ADDENDUM No. 1

City of Austin

Project Name Water Service Line Replacement Program, Indefinite Delivery/Indefinite Quantity

C.I.P. No. 5309.006 IFB No.: 6100 CLMC621

CITY OF AUSTIN AUSTIN WATER		SPECIAL DETAIL - TYPICAL TRENCH WITH PAVED SURFACE USING CLSM (FLOWABLE FILL)	
RECORD COPY SIGNED MICHAEL J. RUSS	05/05/2008 ADOPTED	THE ARCHITECT/ENGINEER ASSUMES RESPONSIBILITY FOR APPROPRIATE USE OF THIS STANDARD.	NO. SD-3 1 OF 1

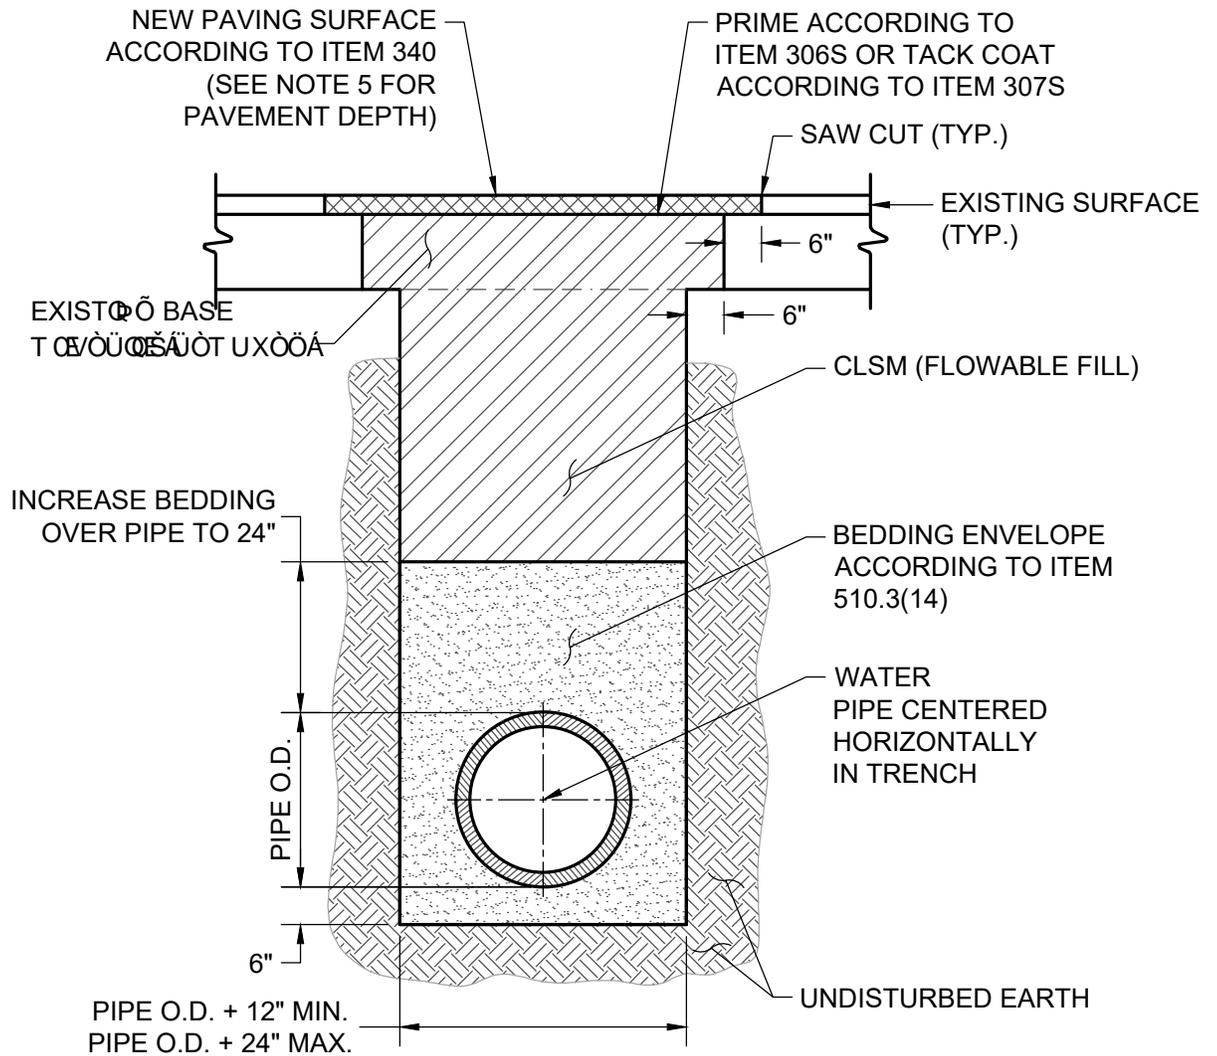
- 10. Specification Item No. 402S, Controlled Low Strength Material: add attached Item No. 402S to the Contract Documents.
- 11. Special Provision to Standard Specification Item No. 402S: add attached SP402S to the Contract Documents.
- 12. Special specification SS520: remove and replace with updated SS520 attached to this addendum.
- 13. Standard Detail No. 1100S-2: remove 1100S-2 from the Contract Documents:
- 14. Special Detail No. SD-3: add attached SD-3, Special Detail - Typical Trench With Paved Surface Using CLSM (Flowable Fill) to the Contract Documents.

4. **Permanent pavement repair shall conform to detail SD-3 and will be paid for according to bid items 340S-A, SP402S-AF, and SP402S-AN.** Refer to detail 430S-4 for backfill under curbs or curb replacement.
